LQ Instrumentation and Quench Protection

Trace Design Summary

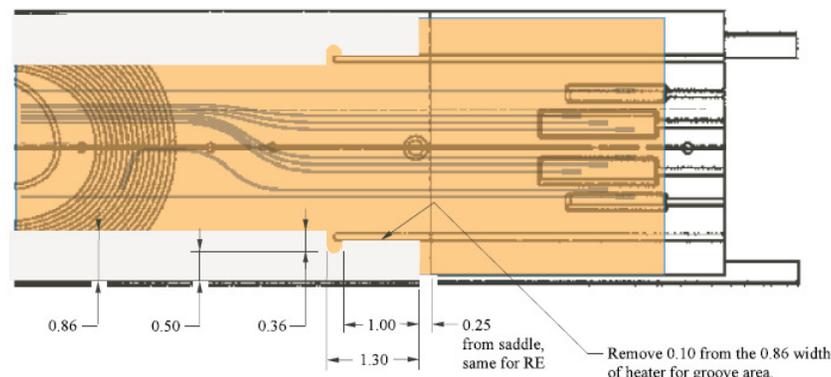
-Modifications in the end region of the heaters have been requested to better fit in the pocket (based on coil #4 and #5 fabrication)

BNL – coil #4 – J. Schmalze

Modification required based on coils #4 and #5 feedback implemented in coil #8 and subsequent coils

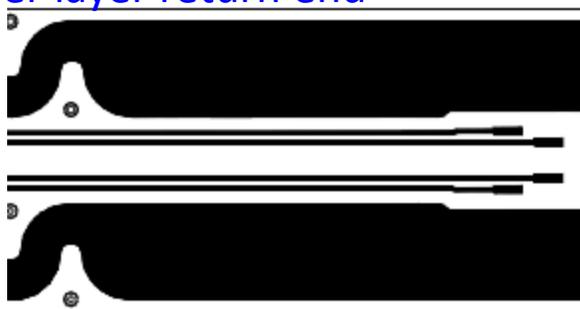
- Increase of spacing between vtaps to allow a hole for the fixation of a G10 strain relief piece on the inner layer return end

Modifications implemented in traces for coil #8 to #11

Trace improvements for next coils

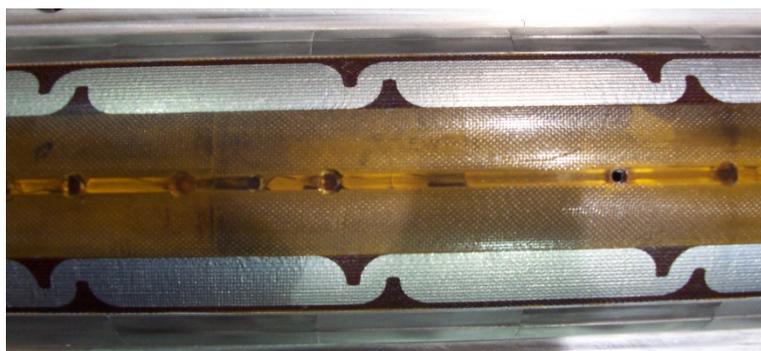
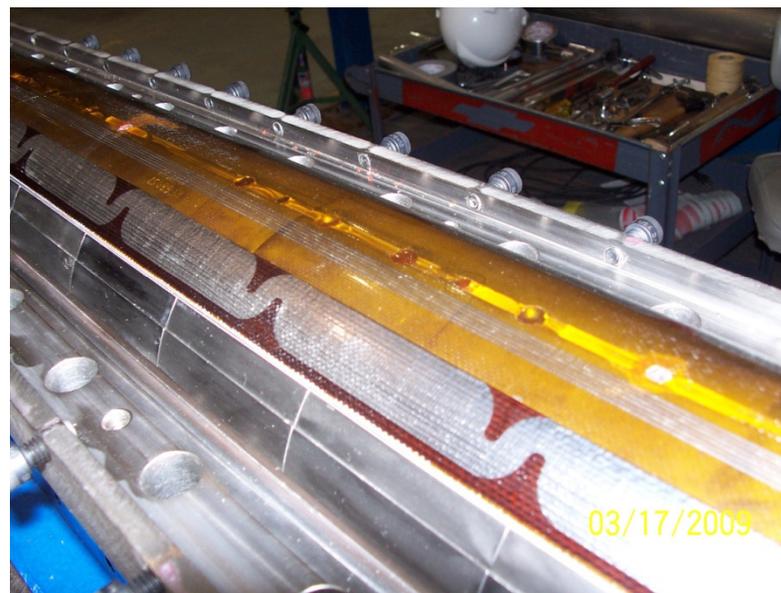
- Request for coil #12 and subsequent coils: to increase the spacing between the coil pole and the heaters

During potting, the trace tends to be sucked by the groove in the pole of the outer layer

Heaters Connections

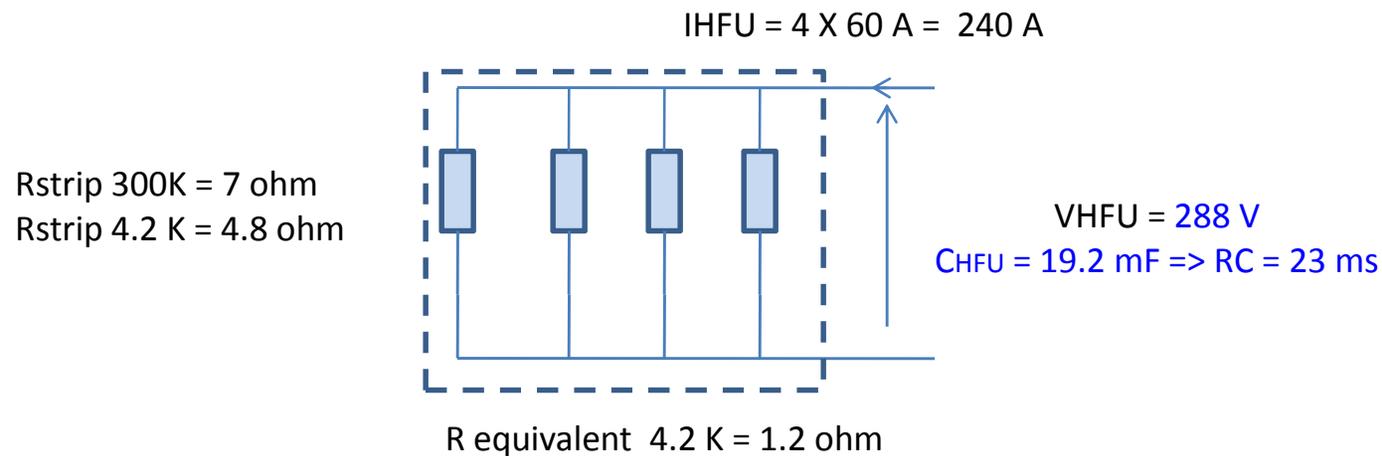
Question: what is the maximum current which can be delivered by each HFU?
